SAN BRUNO MOUNTAIN STATE PARK

GENERAL PLAN

May 1982

ADDENDUM TO THE SAN BRUNO MOUNTAIN STATE AND COUNTY PARK GENERAL PLAN

TRAIL SYSTEM

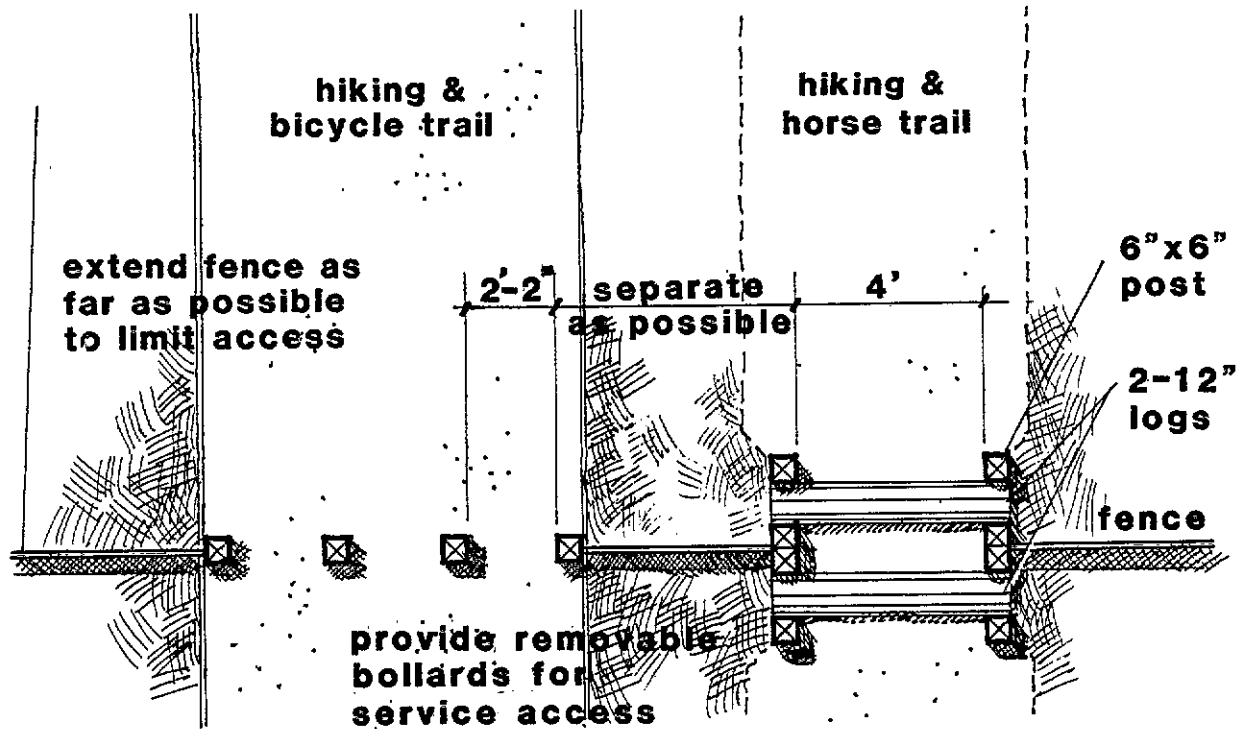
Trail System Map - Change "Hiking Trail" legend to "Hiking and Equestrian Trail."
